#### Regulation No. 125 (Forward field of vision of drivers)

### **Proposal for amendments to Regulation No. 125 (Forward field of vision of drivers)**

#### **Submitted by the expert from Japan\***

Figure 1

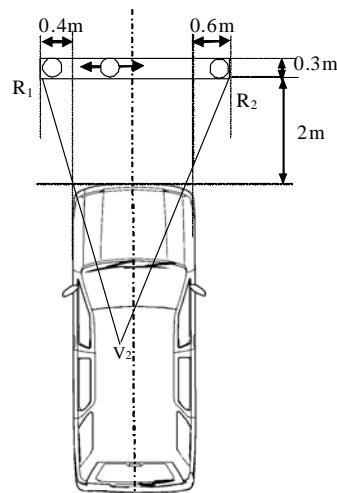
*Insert a new paragraph 5.1.4., including new figures 1 and 2, to read:*

**"5.1.4. A 1.2 m tall cylindrical object with a diameter of 0.3 m that is situated inside the space bounded by a vertical plane located 2.0 m in front of the vehicle, a vertical plane located 2.3 m in front of the vehicle, a vertical plane located 0.4 m from the driver's side of the vehicle, and a vertical plane located 0.6 m from the opposite side of the vehicle shall be at least partially visible when viewed directly from V2 (see figure 1), regardless of where the object is within that space, unless it is invisible due to a blind spot(s) created by the A pillars, windscreen wipers, or steering wheel.**

Figure 2

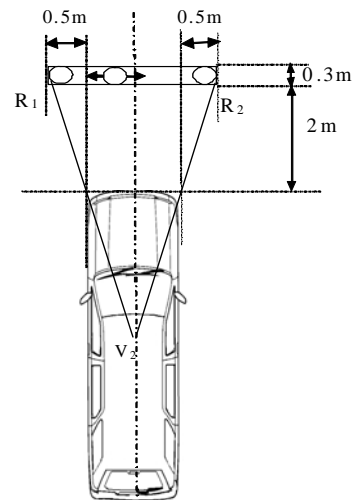
**If the driver's seat is located in the central driving position of the vehicle, the 1.2 m-tall cylindrical object shall be situated inside the space bounded by a vertical plane located 2.0 m in front of the vehicle, a vertical plane located 2.3 m in front of the vehicle, a vertical plane located 0.5 m from the side of the vehicle (see figure 2).**
